# Initial Project Review

## Preliminary Plat: Uplands PDD Phase 1

**Application Numbers: 901234, 902976, 903125, 901235**

## Uplands PDD Final Master Development Plan, November 16, 2018 Draft

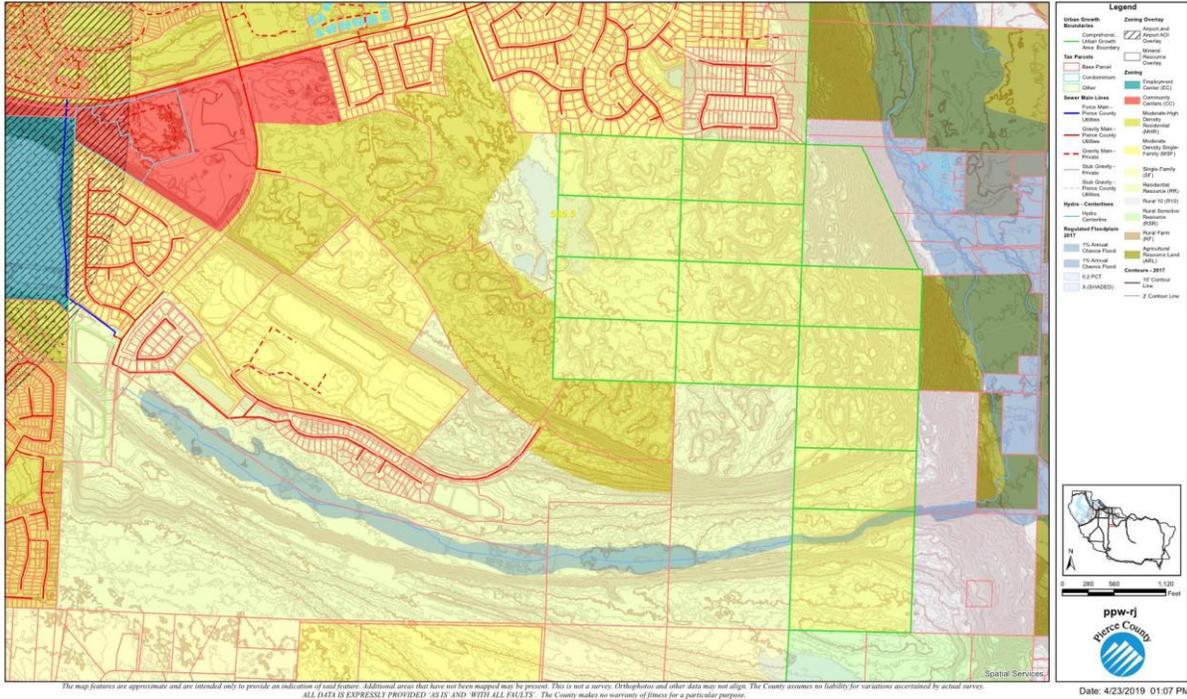
- Housing Mix:
      - Proposed duplex and townhouse housing types on a single lot of record provide housing opportunities for younger and moderate-income groups similar to original small lot concept.

- Owner occupied housing for younger and moderate non-age qualified income groups should still be provided. Revision of Tract L to include a range of lot widths starting at 40 feet would be consistent with the preliminary PDD approval.

- Future incorporation of alley-loaded product is encouraged but not required to be reflected on the master plan.
    - Open Space:
      - Applicant believes that the requirement for 39%/126 acres of open space was a clerical mistake and the preliminary PDD approval was for 35.63%/113.97 acres. This issue will need to be clarified by the Hearing Examiner during the first preliminary plat approval.

- Need to confirm the square footage of the "open space" areas shown in dark green on the Master Development Plan and Open Space-Recreation Plan.

- Staff would support the “linear park” concept only under these conditions: 1) Design the facility per the Urban Trail standard in the Parks, Recreation and Open Space (PROS) plan; and 2) credit for the right-of-way area between back of curb and a minimum of 23 feet to the outer edge of the right-of-way line for the north side of 176<sup>th</sup> Street East Extension (130<sup>th</sup> Avenue East) and the north side of Rainier View Blvd. East.

- Need to revise the Master Plan and Park Plan to locate additional active or passive recreation areas since the staff supported linear park concept will not equal the 2.92 acres of linear park proposed by the applicant.

- Resource Management Section of PPW:
  - Wetland approval has been pending applicant's posting of buffer notices and recording of Approval on Title.
  - PDD design has changed considerably since time of Approval issuance. As such, please add the following note to the face of the Final Master Plan: "Proposed residential development in Tract L-southeast portion of project, near Lorenz Creek, has not been reviewed at a development level pursuant to PCC 18E.30. and 18E.40. Proposed lot placement, density, and road configuration are subject to change when a preliminary plat application is submitted for review."

# Overall Preliminary Plat Map, Phase 1, dated December 2018

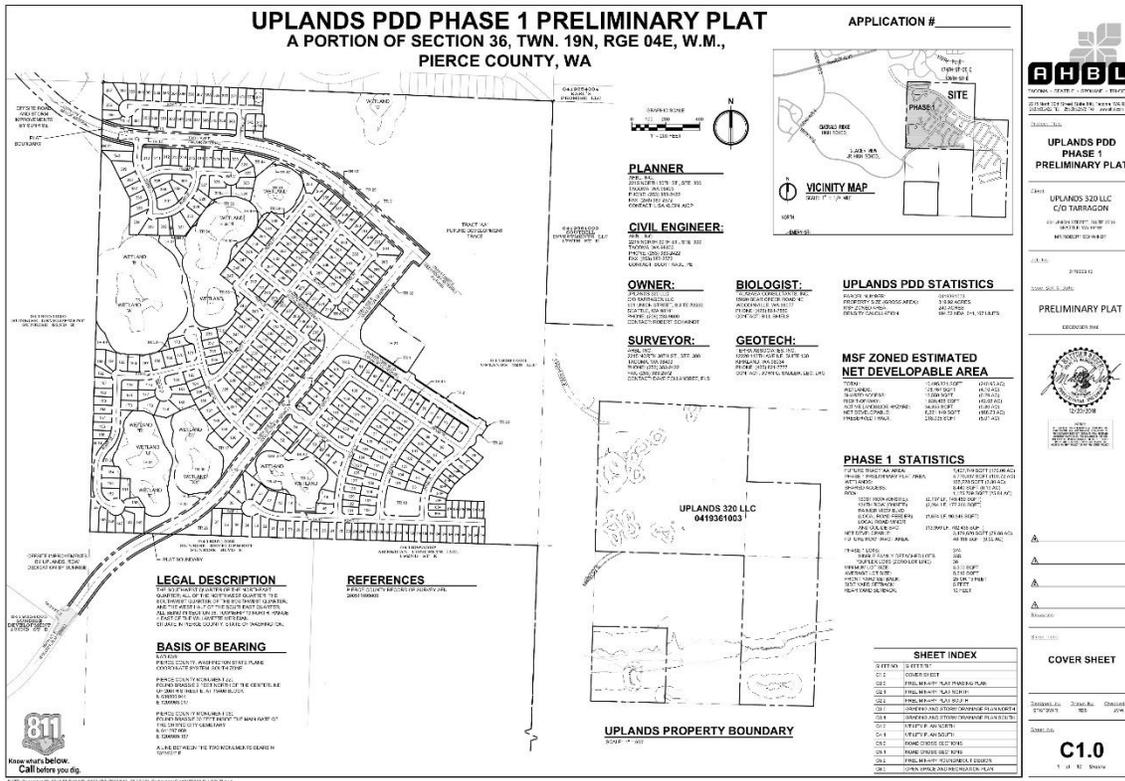
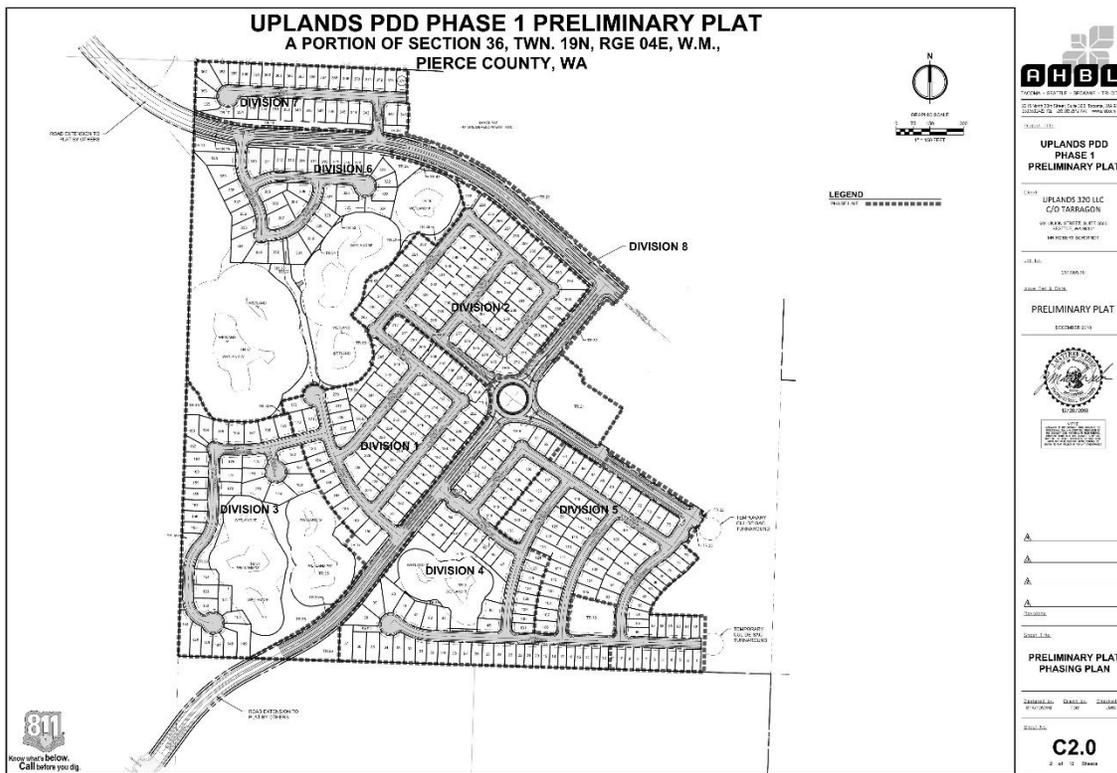
- Retaining walls of up to 13 feet in height are proposed along the rear of Lots 321-330. Section 18J.15.015.D.5 does not permit walls exceeding 8 feet in height. The applicant needs to explain why the road and lot layout west of Wetlands H and J cannot be designed to slope toward the wetland and avoid use of walls or at least be restricted to walls less than 4 feet in height, per 18J.15.015.D.2. and D.4. All walls exceeding 4 feet will need to be screened with an L1 landscape buffer, per 18J.15.015.D.7. The proposed walls will require application for Site Plan Review approval if exceeding 8 feet in height. Applicant needs to explain how resident and child safety will be maintained with tall walls at the rear of homes and abutting a wetland.

- Applicant needs to clarify if there will be a two-unit duplex placed on the "duplex" lots or if the intention is for these lots to be "zero-lot-line single family" instead, i.e., a duplex building divided by a lot line.

- A flood hazard area exists on this site. A Flood Boundary Delineation Survey needs to be submitted for review and approval.
  - There are several road design items that do not meet standards, including several of the cul-de-sac streets. The site plans should be revised appropriately or application for road deviations submitted.

- The site plans show proposed storm drainage systems which will not meet standards for a public storm drainage system. While the storm drainage system is not being reviewed at this time, the applicant should take this under consideration as revisions may result in the need for additional public storm drainage tracts.

# Open Space and Recreation Plan, Pahse 1, dated December 2018

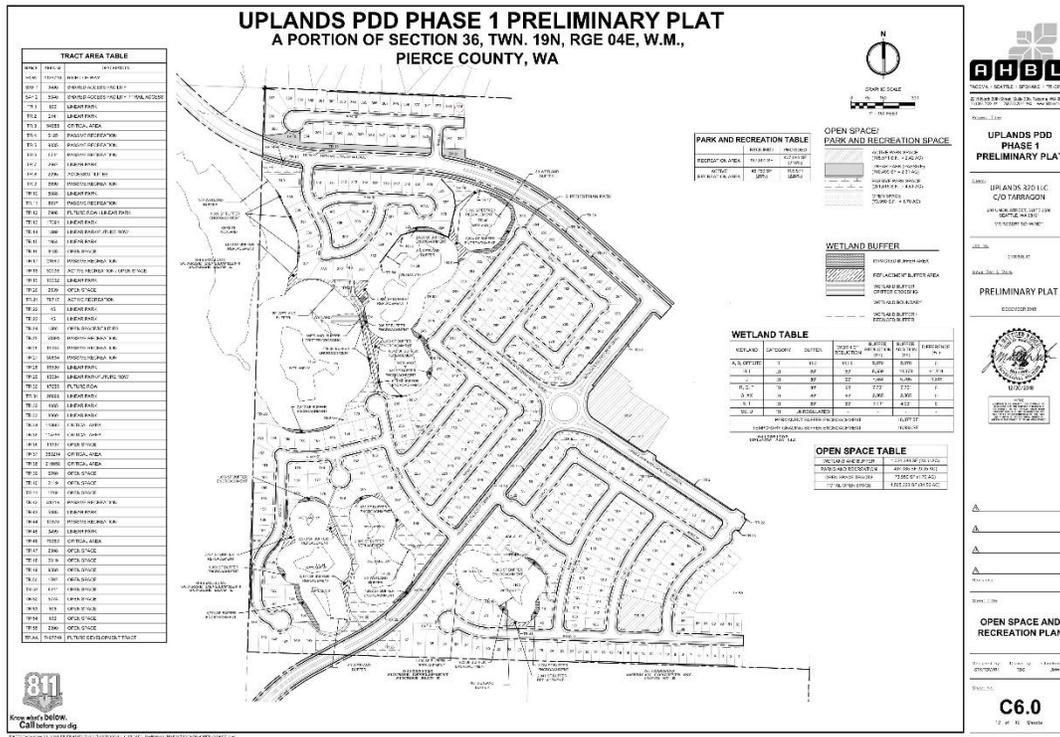
- Recreation:
      - Need to connect the cul-de-sacs in the Tract K and L neighborhoods with pervious pathways connections and show this on the Open Space-Recreation Plan and Trails and Connectivity Plan.

- Need to correct the legend on the Open-Space-Recreation Plan to show the color and cross-hatch of active parks - it is missing.
      - Need to make sure that the active and passive park tracts are consistent between plans - there is a discrepancy between the Open Space-Recreation Plan, the Phasing Plan, and the Trails and Connectivity Plan.
